PDMS Model Review Report (30%) - GCS

نگهداشت و افزایش تولید میدان نفتی بینک

This document presents all raised issues and made decisions during 30% model review session

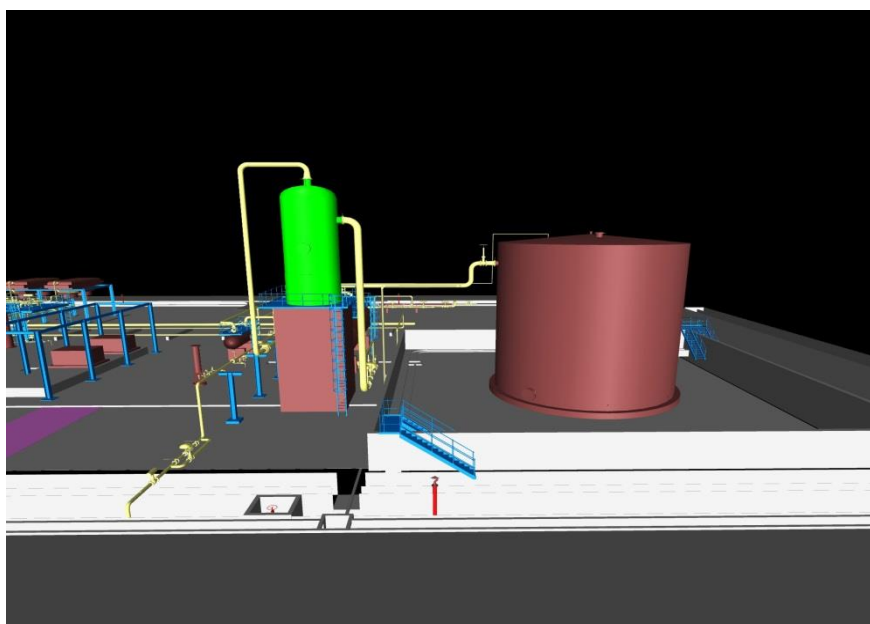
- 6.1** Surveying data of existing inlet gas pipeline from BINAK cluster and branch of new line for new gas compressor station on it should be shown in 60% 3D model

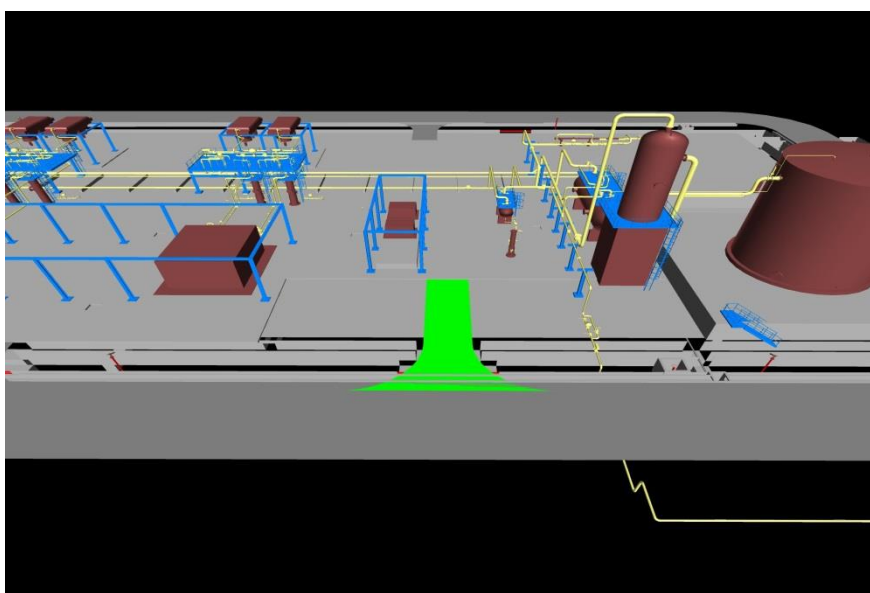
6.2 It is decided that sunshade should be considered for condensate pumps

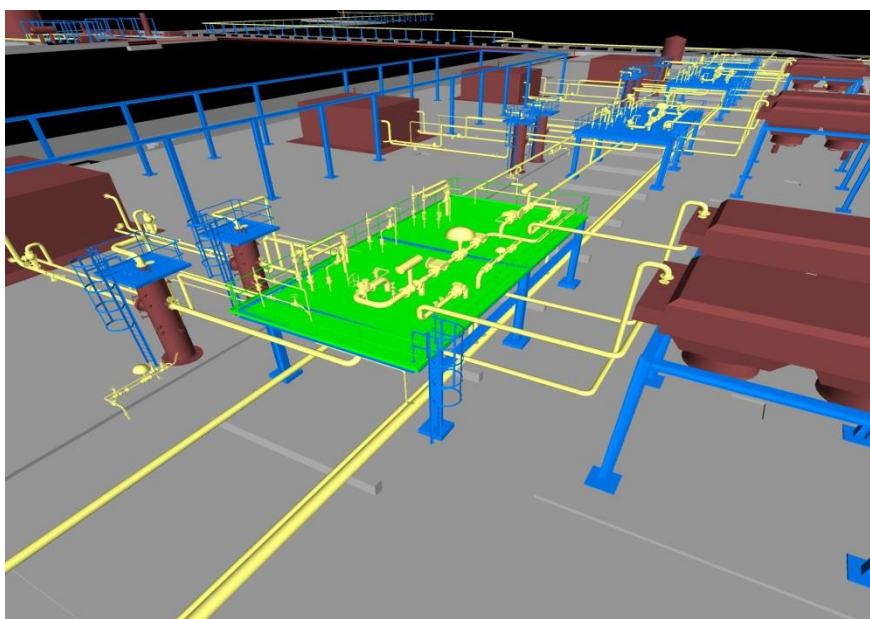
6.3 Location and installation elevation of Degassing Vessel and also piping between Degassing Vessel and Condensate Tank should be reviewed and shown with more detail

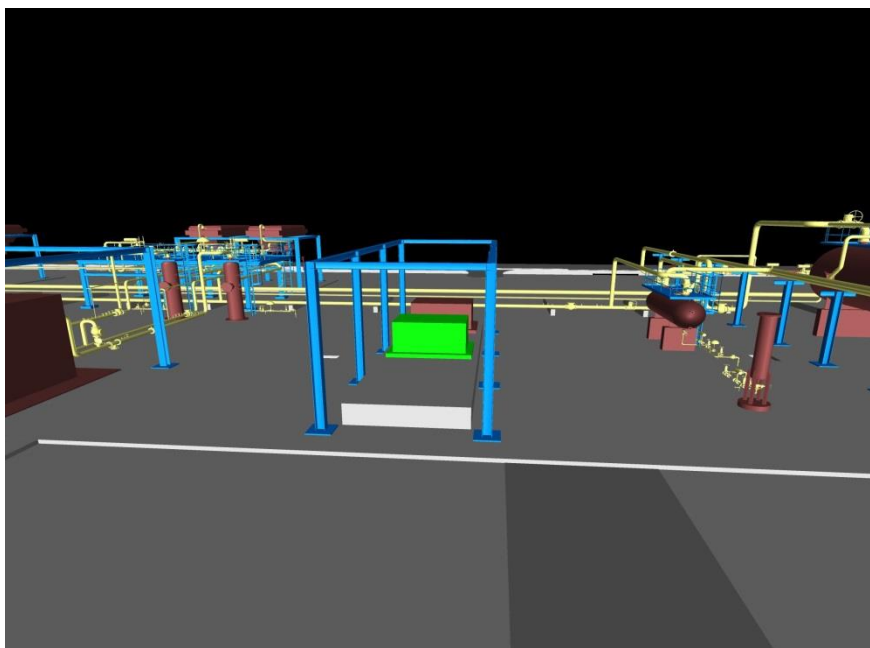
- 6.4** Access road of chemical shelter should be moved toward east so that more access room to be provided for other equipment which are located between mentioned shelter and Condensate Tank

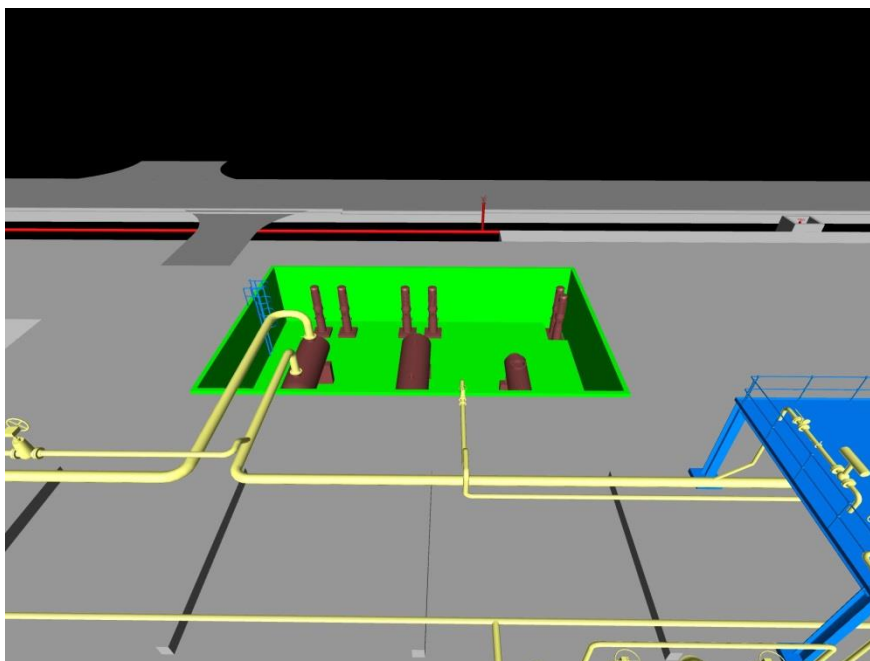
- 6.5** Staircase should be considered for structures of control valves and PSVs of compressors instead of ladder. For train C a ladder should be considered in addition.

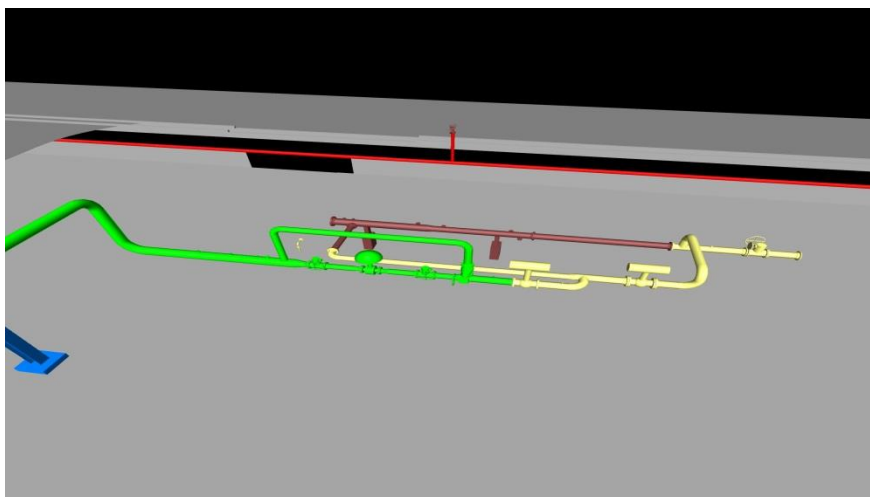
6.8 It was stated that an open channel network to be considered to collect process open drainage and surface oily water simultaneously. Also, closed drain pipe network to be located inside of mentioned channel. This channel should be covered by grating. **Separate open channel should be considered for clean surface water system.**
